# UNITED STATES PATENT AND TRADEMARK OFFICE

10/568,812

Stanislaw Bodzak

<b>Office Action Summary</b>	<b>Application No.</b> 10/568,812	<b>Applicant(s)</b> BODZAK, STANISLAW	
	<b>Examiner</b> TODD D. JACOBS	<b>Art Unit</b> 3746

**Fig. 4**

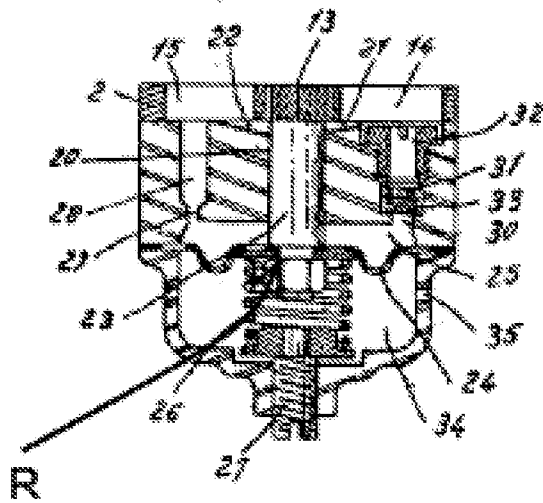
19. In re claim 22, with reference to figure 4, Zenith discloses that as pressure in the delivery chamber (13) increases, the valve piston (23) opens an ever greater through flow cross section in the connecting conduit (21).

20. In re claims 23-24, with reference to figure 4, Zenith discloses the diameter of the valve piston (23) greater than the width of the connecting conduit (21).

**Fig. 2**

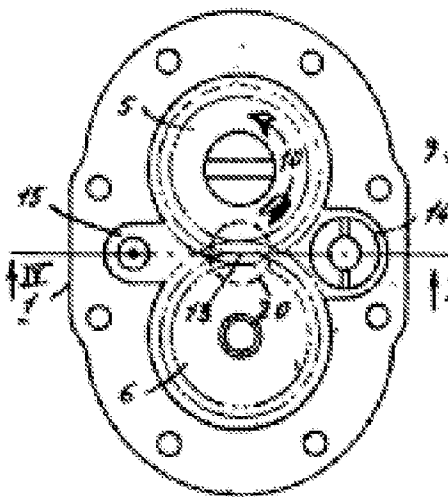
17. In re claims 15-18, with reference to figures 2 and 3, Zenith discloses the valve piston (23) at least partially delimiting the pump chamber (13) in the direction of the rotation axis of the at least one delivery element (5, 6), wherein the closing spring (26) presses the valve piston (23) against the end surface of the at least one delivery element (5, 6) oriented toward it, which end surface functions as a valve seat, and wherein the pressure prevailing in the pressure chamber (25) acts on at least part of the end surface of the valve piston (23) oriented toward the at least one delivery element (5, 6).

18. In re claims 19-21, with reference to figures 2 and 4, Zenith discloses a connecting conduit (21) between the delivery chamber (13) and the intake chamber (14) embodied in the form of a groove let into a housing part facing the end surface of the at least one delivery element (5, 6) and the valve piston controls the passage through this groove.

**Fig. 3**

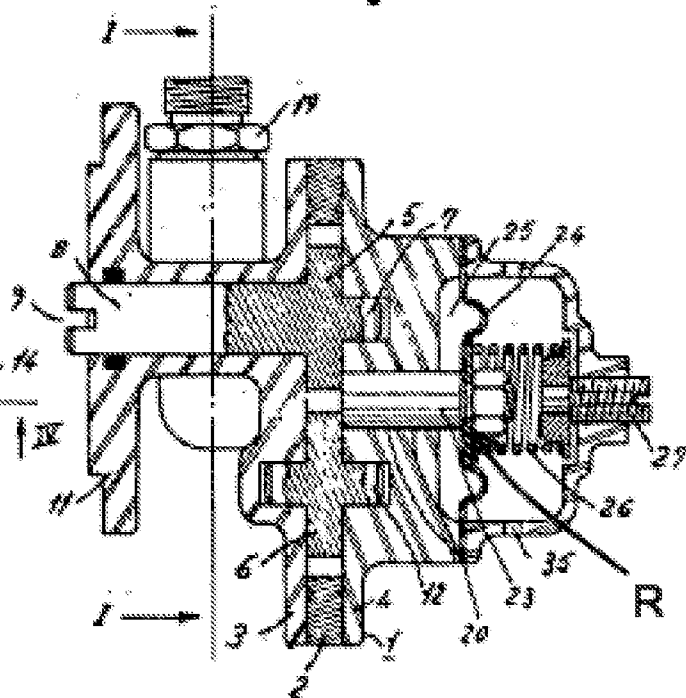
10. Nevertheless, Zenith, with reference to figure 3 below, describes a fluid pump with a pressure chamber (25) wherein the pressure prevailing in the pressure chamber (25) influences the force on the valve piston (23) in the closing direction in such a way that as the pressure in the pressure chamber (25) decreases, the force on the valve piston (23) in the closing direction increases. The advantage of this pressure chamber, as described by Zenith on page 1, line 34 is to “provide in a pump of this type an exact regulation of the pump delivery pressure”.

13. Note further that the combination of AAPA/Zenith will inherently consist of **the valve piston being offset from a connecting line between the axes of rotation of the two delivery elements**. Fig.3 above clearly shows this because the axes of rotation of 5 and 6 extend left/right for a far length at least as far as the rotors themselves, but actually, an infinite distance. One can see above that at the far left portion of each rotor, 5 and 6, if a connecting line were to be made between those points, the piston valve would certainly be offset from that line.

14. In re claim 11, with reference to figure 3 above, Zenith discloses the pressure chamber (25) delimited by a moving wall (24), one side of which is acted on by the pressure prevailing in the pressure chamber (25) and the other side of which is acted on by a prestressed spring (26) that pushes the wall (24) toward the valve piston (23) in its closing direction.

16. In re claims 13-14, with reference to figure 3 above, Zenith discloses the moving wall (24) is embodied in the form of a diaphragm.
